Access Compliance Report

Public Rights-of-Way

(Curb Ramps)

Intersection ID: 28440	Main Street: DEARMON_RD	Cross Street: PROSPERITY_VILLAGE_DR	Location: N
ADA ID: D53D049A175E	Ramp Type: Perp	Initial Pass/Fail: Fail	Overall Compliance: No
Severity Score: 58.75			
Codes/Mitigation Info/Possible Solution		Field Measurements/Component Compliance

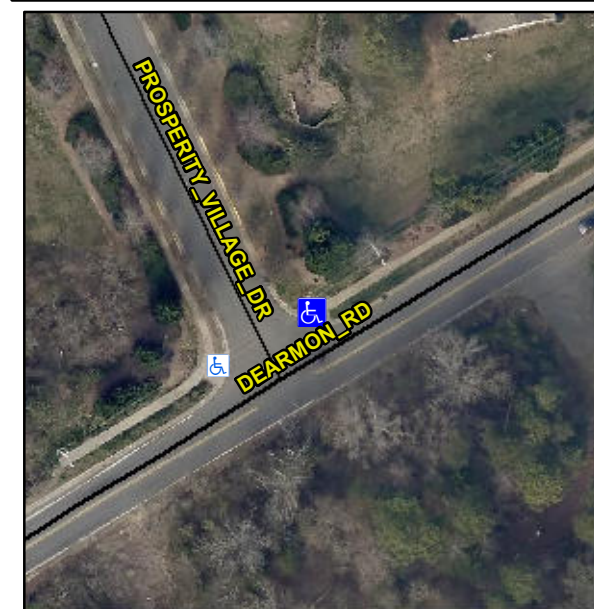
R304.5.1, R304.2.2, R304.5.3

Compliance	Description	Data	Compliance	Description	Data
N/A	Ramp Length (in)	124.5	No	Ramp Slope (%)	14.7
No	Ramp Width (in)	37.0	No	Ramp XSlope (%)	15.0
N/A	Flare Type LT	N/A	N/A	Flare Type RT	N/A
N/A	Flare Slope LT (%)	N/A	N/A	Flare Slope RT (%)	N/A
N/A	Flare Traversable LT?	N/A	N/A	Flare Traversable RT?	N/A
N/A	Landing Length (in)	N/A	N/A	DWS Provided?	N/A
N/A	Landing Width (in)	N/A	N/A	DWS Contrast?	N/A
N/A	Landing Slope (%)	N/A	N/A	DWS Length (in)	N/A
N/A	Landing X Slope (%)	N/A	N/A	DWS Full Width?	N/A
N/A	Landing Curb? (Y/N)	N/A	N/A	DWS Offset (in)	N/A
N/A	Shared Landing?	N/A			
N/A	Gutter Ponding?	N/A	N/A	Gutter Slope (%)	N/A
N/A	Gutter Lip Ht (in)	N/A	N/A	Gutter X Slope (%)	N/A
N/A	Painted X Walk1?	No	N/A	Painted X Walk2?	N/A
	X Walk 1 Direction	To SW		X Walk 2 Direction	N/A
N/A	X Walk 1 Width (in)	N/A	N/A	X Walk 2 Width (in)	N/A
	X Walk 1 Slope (%)	13.7		X Walk 2 Slope (%)	N/A
	X Walk 1 X Slope (%)	12.8		X Walk 2 X Slope (%)	N/A

Remove & Replace Entire Ramp.
